PUBLIC UTILITIES COMMISSION

RE: Request for Additional Data #23 – Certificate of Public Convenience and Necessity for the Sycamore-Peñasquitos 230-Kilovolt Transmission Line Project – Application No. A. 14-04-011

**Magnetic Field Calculations Provided in Response to
CPUC Data Request #10 for the Proposed Sycamore to
Peñasquitos 230 kV Transmission Line Project
Revised Version per CPUC Data Request #19**

Alternative 3 Map: Pomerado – Miramar Area North Combined Underground and Overhead

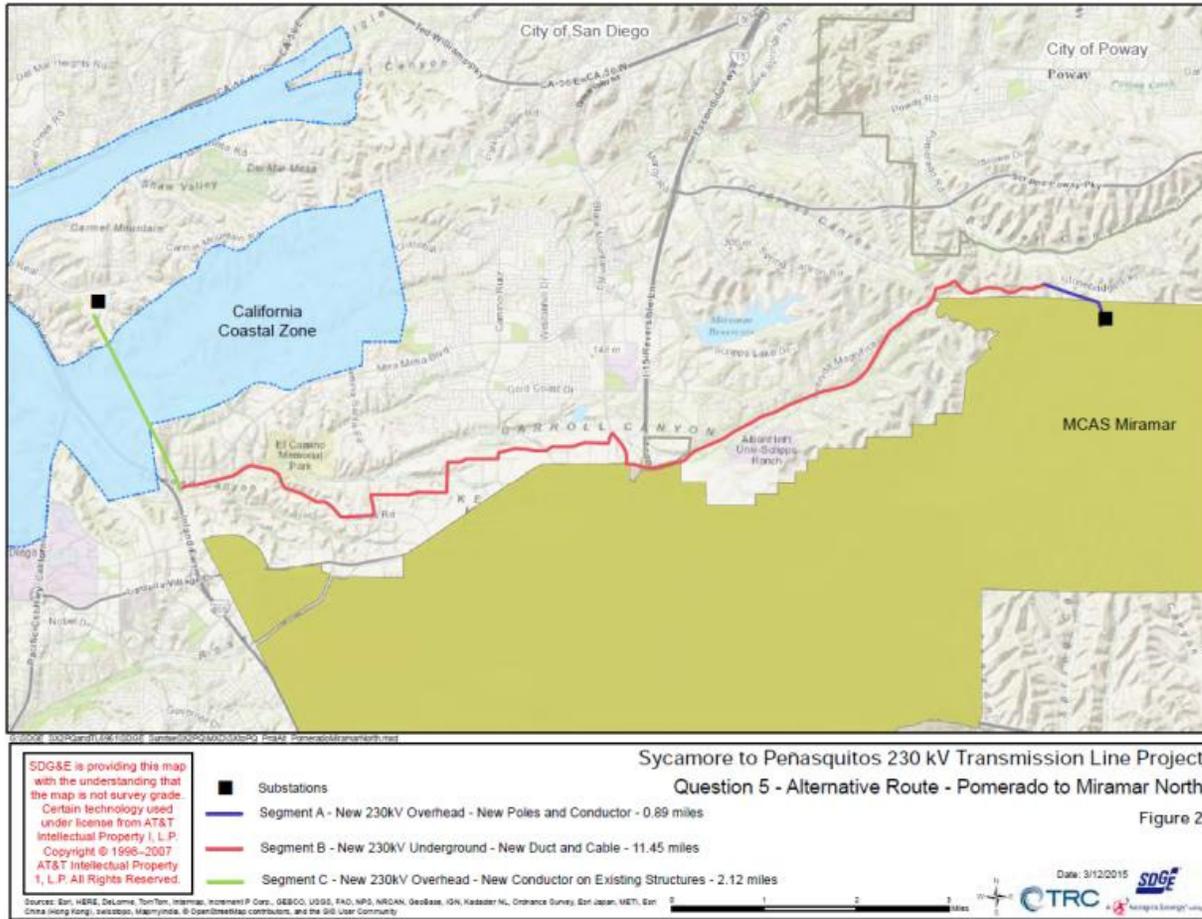
Commented [A22]: Alternative 3

Alternative 4 Map: Pomerado – Miramar Combined Underground and Overhead

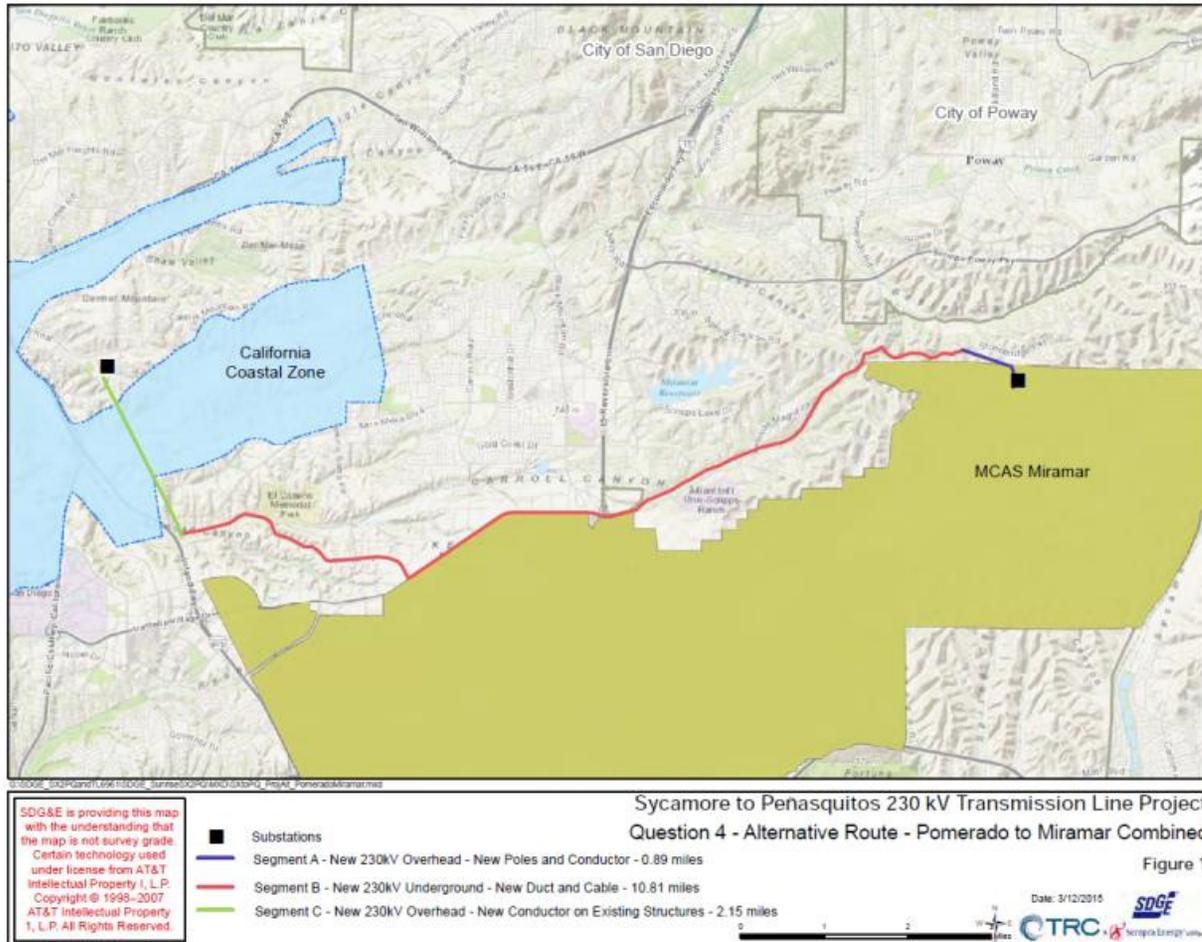
Commented [A24]: Alternative 5

Alternative 5 Map: Partial Segment D 69 kV Underground

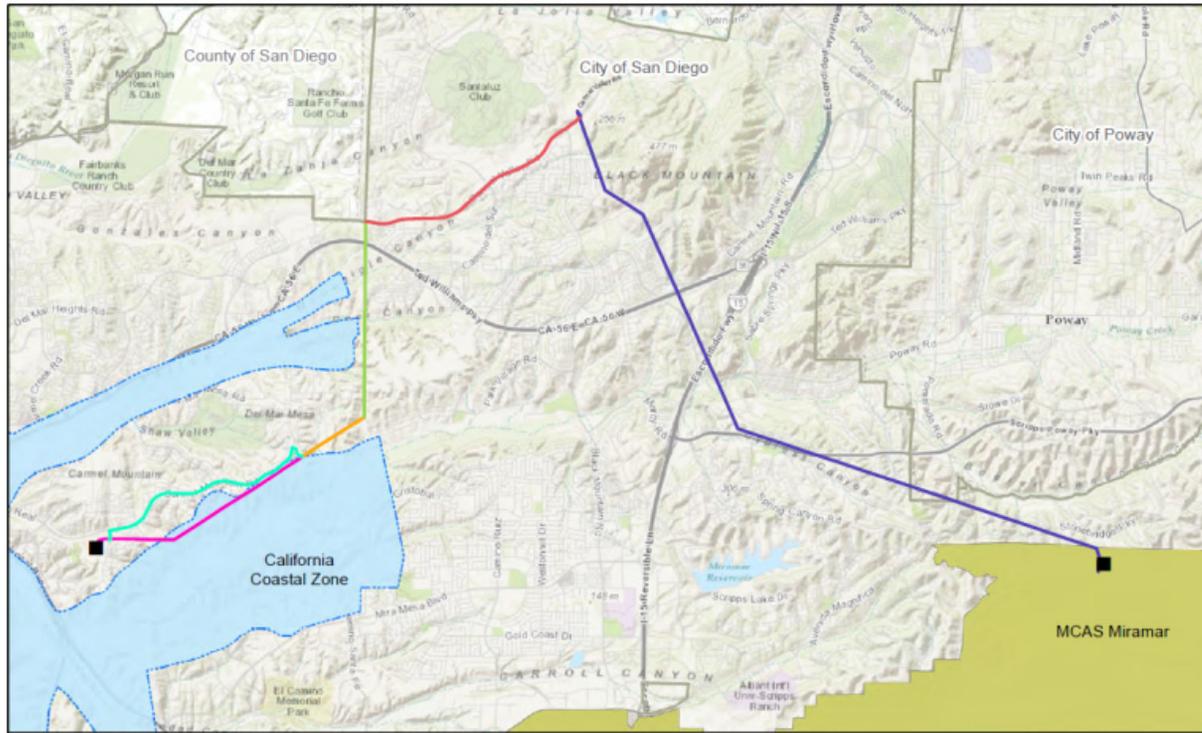
Commented [A25]: Not carried forward

Commented [A26]: Alternative 4
